**RE: 2019-492 Jindera Solar Farm (SSD 9549) - Notice of Exhibition**

Figure A: Fencing Elevation

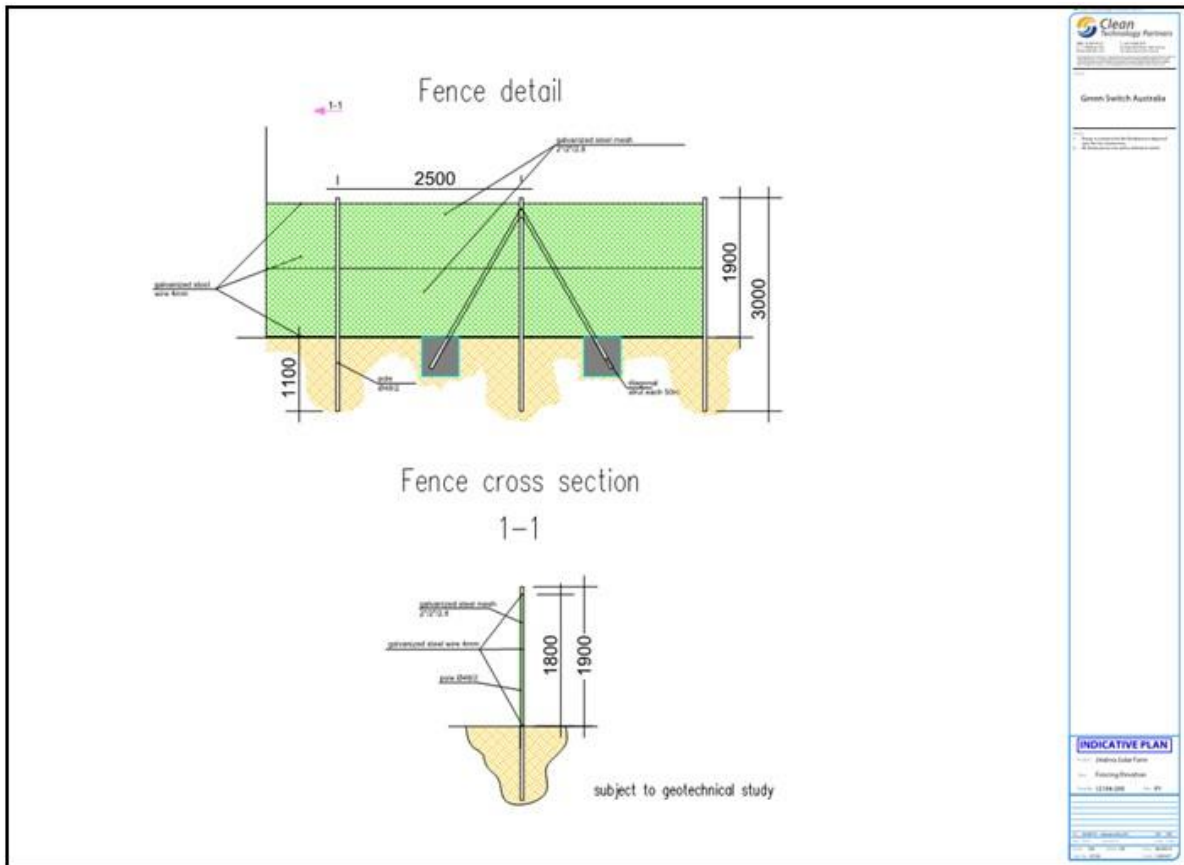
- The following conditions are placed for the Fences:
  - As per the TransGrid Fencing Guidelines, fences parallel to a transmission line outside the easement:

- Metal fence within 10m of the easement must be earthed once in line with each structure and once in the middle of each span.
    - Metal fence within 20m of the easement must be earthed once in line with each structure.
